Regarding: Response to Ecology December 5, 1994 Comments
On Draft Aquifer Management, Quality Assurance,
Field Sampling Plans, and Computer Simulation

TECHNICAL MEMORANDUM

RE: **RESPONSE TO ECOLOGY AND EPA COMMENTS
ON THE INTERIM DRAFT AQUIFER MANAGEMENT,
QUALITY ASSURANCE AND FIELD SAMPLING PLANS,
AND COMPUTER SIMULATION
FOR THE COLBERT LANDFILL REMEDIAL ACTION**

Figure 2

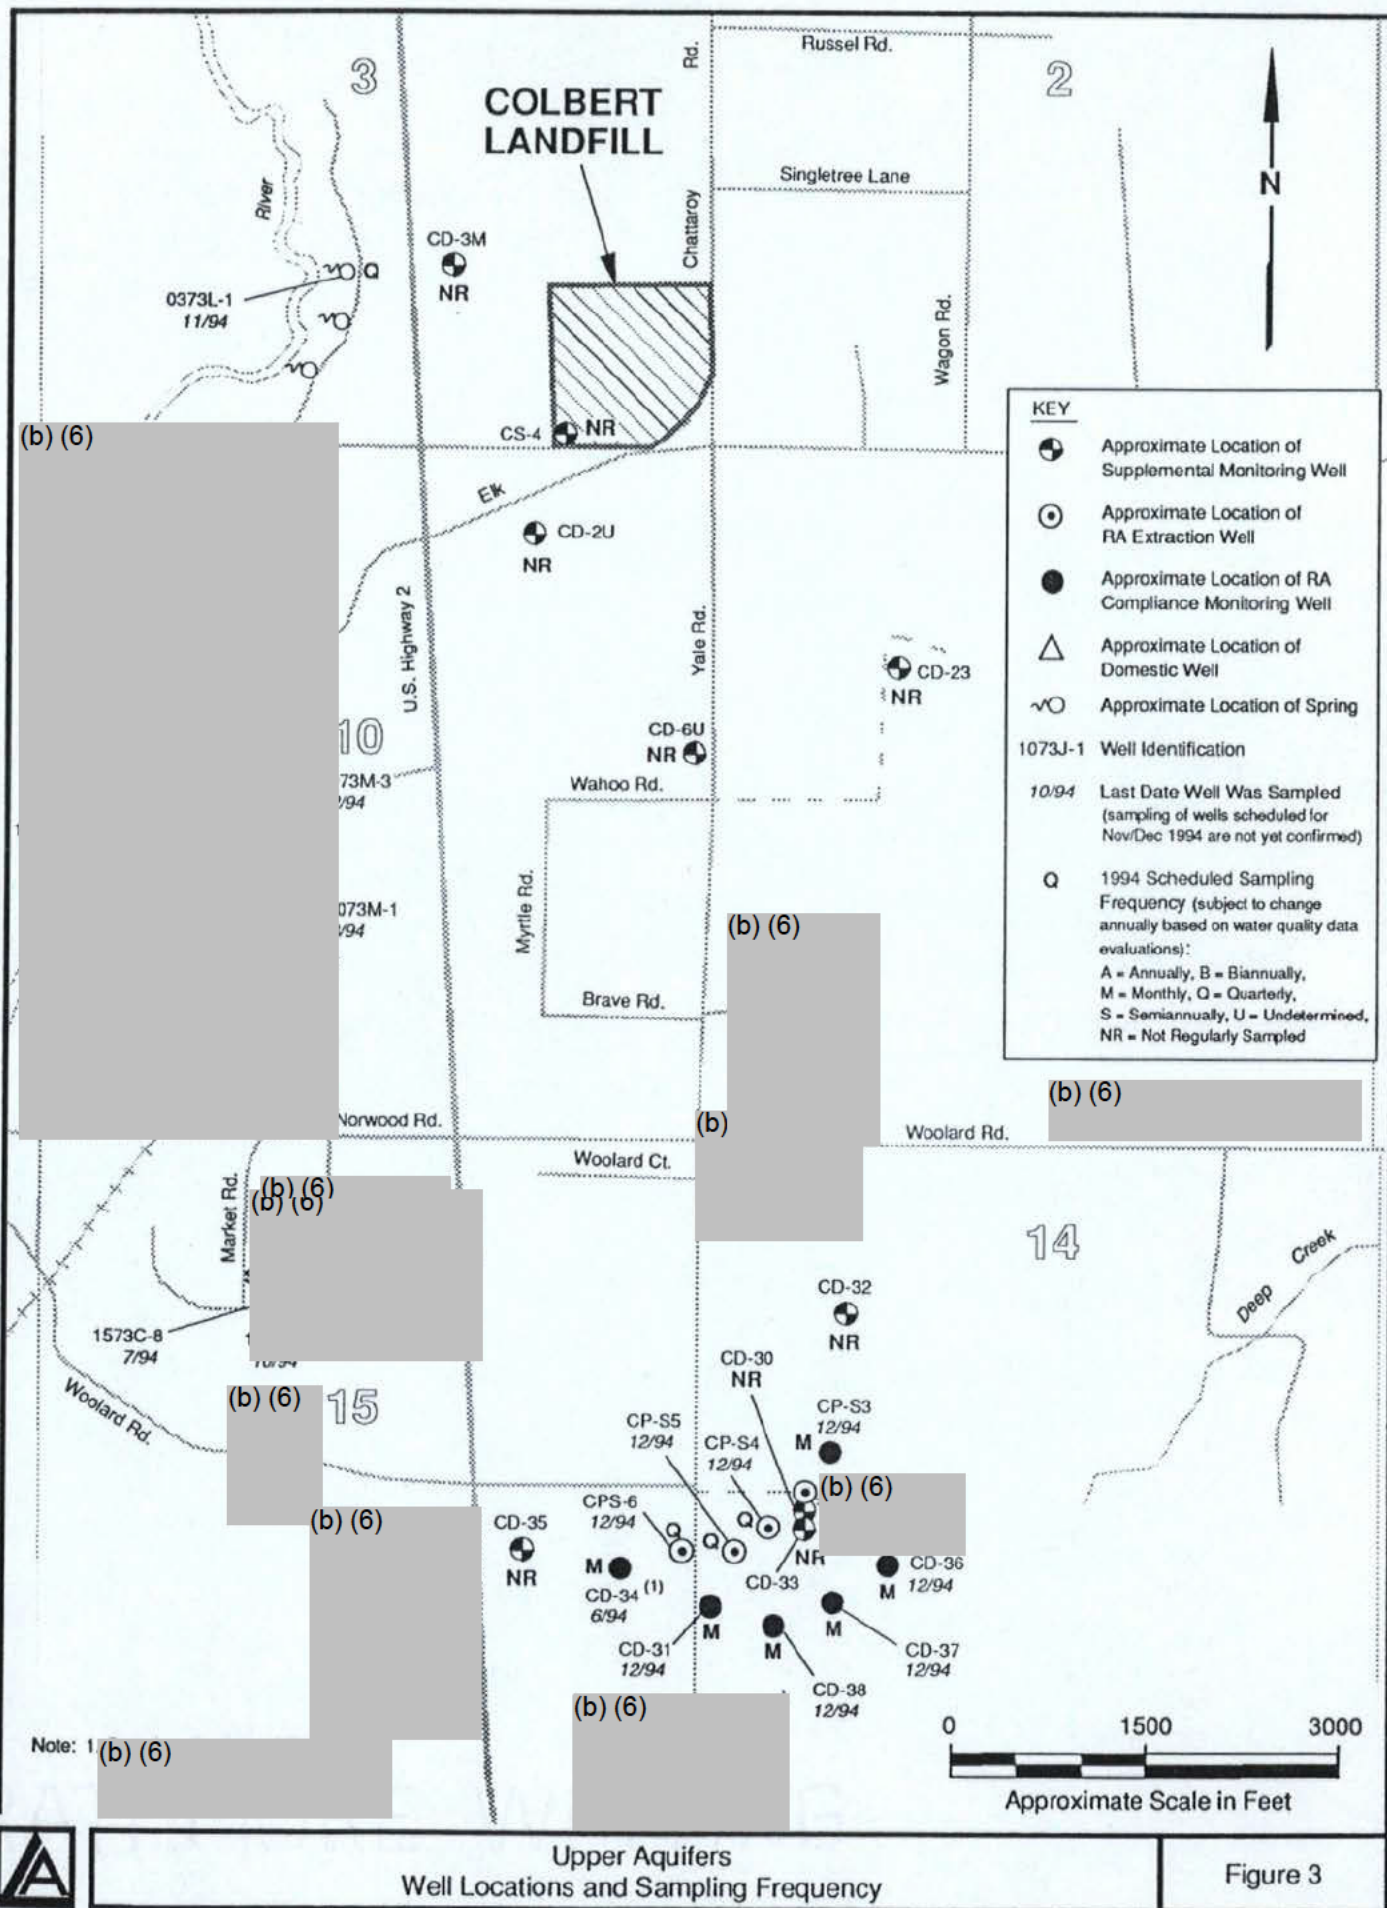
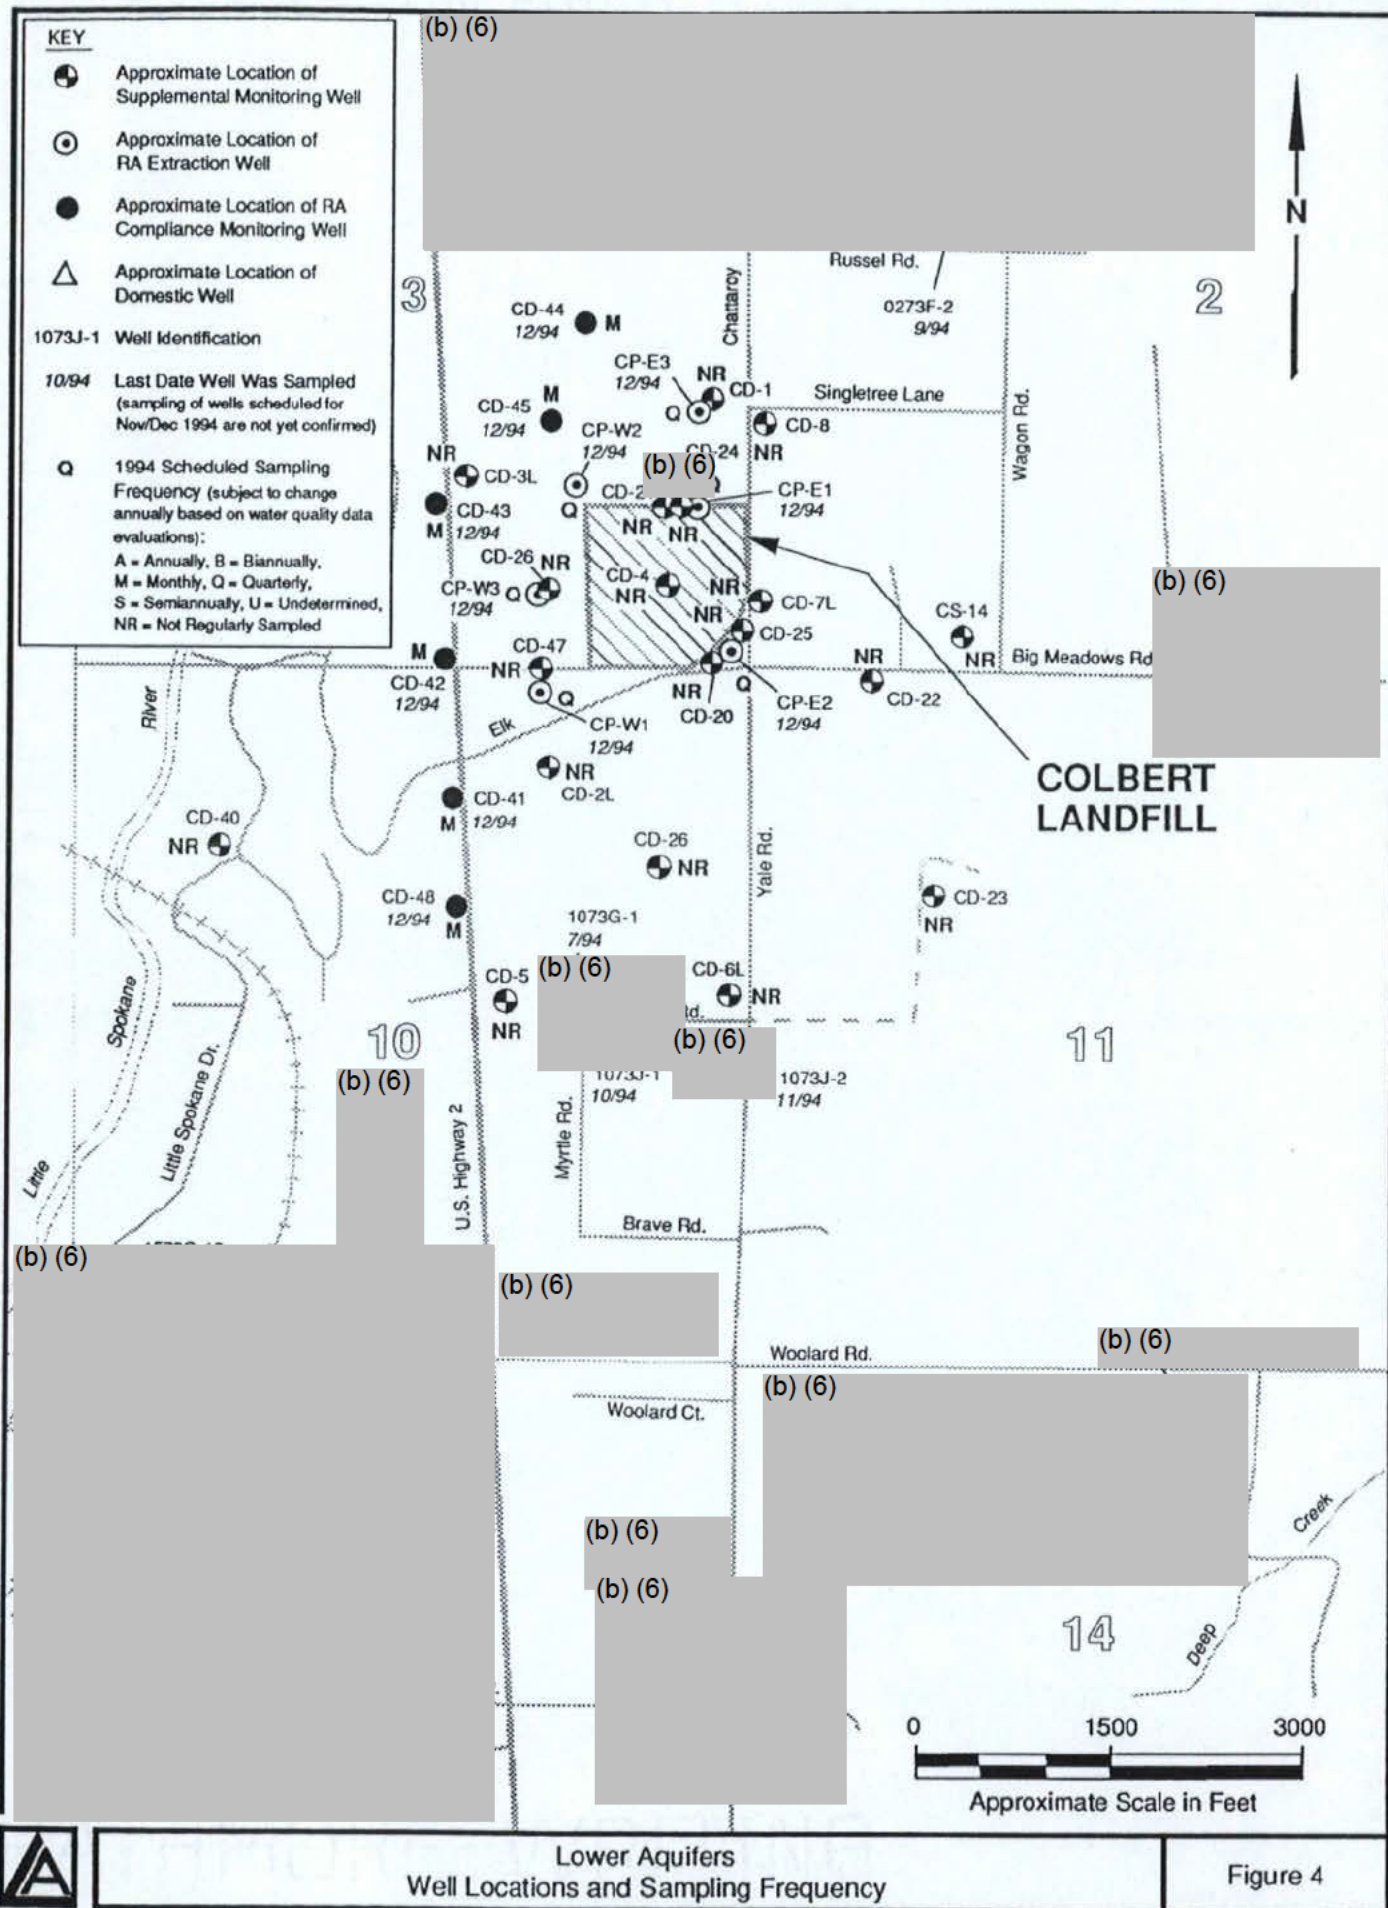
14. Regarding both figures 7-3 and 7-4, the period for which the data was gathered is not identified. If the period for data gathering exceeds six months, the data would very likely be influenced by seasonal variation in groundwater. Standard operating procedures for contaminant distribution maps usually require the data be gathered within a six month period or less. What is the period for gathering the data which is plotted on figures 7-3 and 7-4? Are seasonal variations in groundwater quality factored into figures 7-3 and 7-4?

We propose to replace Figure 7-3 with Figures 1 and 3 presented herein. We request that Ecology and EPA indicate whether this is acceptable, and if not, what additional information is needed.

We propose to replace Figure 7-3 with Figures 2 and 4 presented herein. We request that Ecology and EPA indicate whether this is acceptable, and if not, what additional information is needed.

See responses to comments 12 and 13. To the extent practicable, the data presented on Figures 1 and 2 are from a six month period. However, some data (as identified on the figure) are outside of this time frame due to the limitations of available data. However, the data are adequate to meet the intent of the figure, which is to identify the extent of the affected area to the reader. Although no detailed evaluation has been performed on the impact of seasonal fluctuations in groundwater quality, no obvious relationships are apparent from a qualitative review of the data.

Figure 5

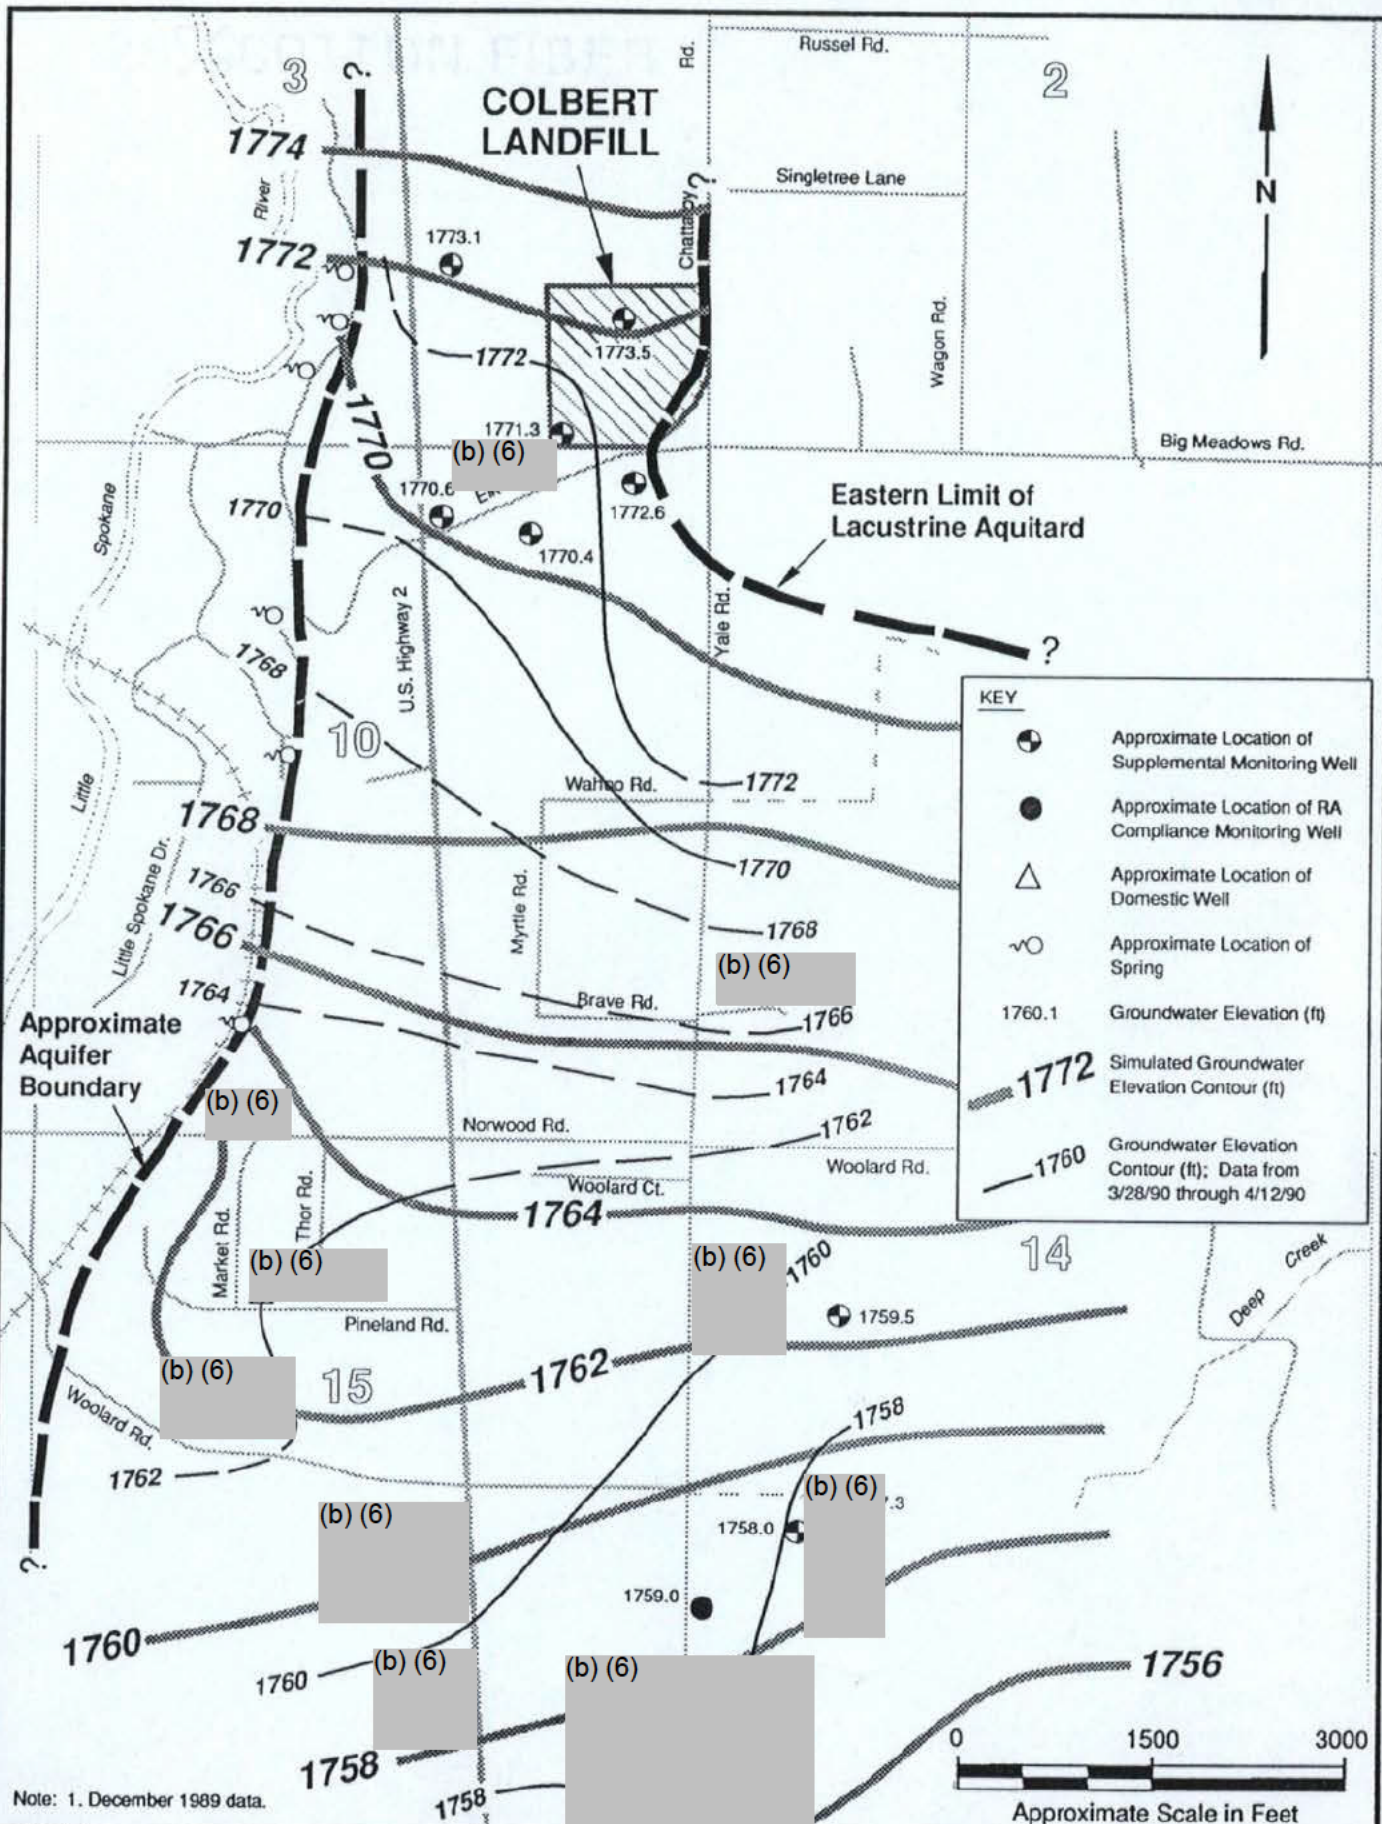
The data base for calibrating aquifer simulation consists of a "snapshot" of water levels taken during a short period during 1990. It is very possible that the relationship of water levels in the measured wells varies with the seasons and thus the flow direction would change with the seasons. Perhaps 1990 was a

A valid data base for computer simulation would consist of several measurements taken on a seasonal basis. We suggest the County either do this or show by means of a hydrograph for several wells that the "snapshot" is representative.

The commentor is correct in pointing out that a single round of groundwater elevation data are inappropriate for use in modeling groundwater flow, due to potential seasonal fluctuations. Landau Associates evaluated groundwater elevation data from six rounds of water levels collected between August 1989 and November 1990. These data are presented in Table ER-3.1 of the Phase I Engineering Report, and are reproduced in Table 1 presented herein. Also presented in Table 1 are data from a June 1993 measurement round to allow comparison over multiple years.

The March 28 through April 12, 1990 round of water elevation data were used for modeling purposes because they represent the most comprehensive round of water elevations collected for the project, and because the data strongly support the conclusion that water elevations do not vary significantly on a seasonal basis, or from year to year. This conclusion is based on the data discussed in response to the first question posed in this comment and the data in Table 1. With the exception of two measurements, including one that appears to be erroneous (b) (6), August/September 1989), the maximum difference between the April/May 1990 measurement round and any other measurement round is less than 1 ft. These data indicate that seasonal and annual fluctuations in the Upper Sand/Gravel Aquifer groundwater elevations are minimal, particularly when considered in conjunction with the data presented earlier in this response.
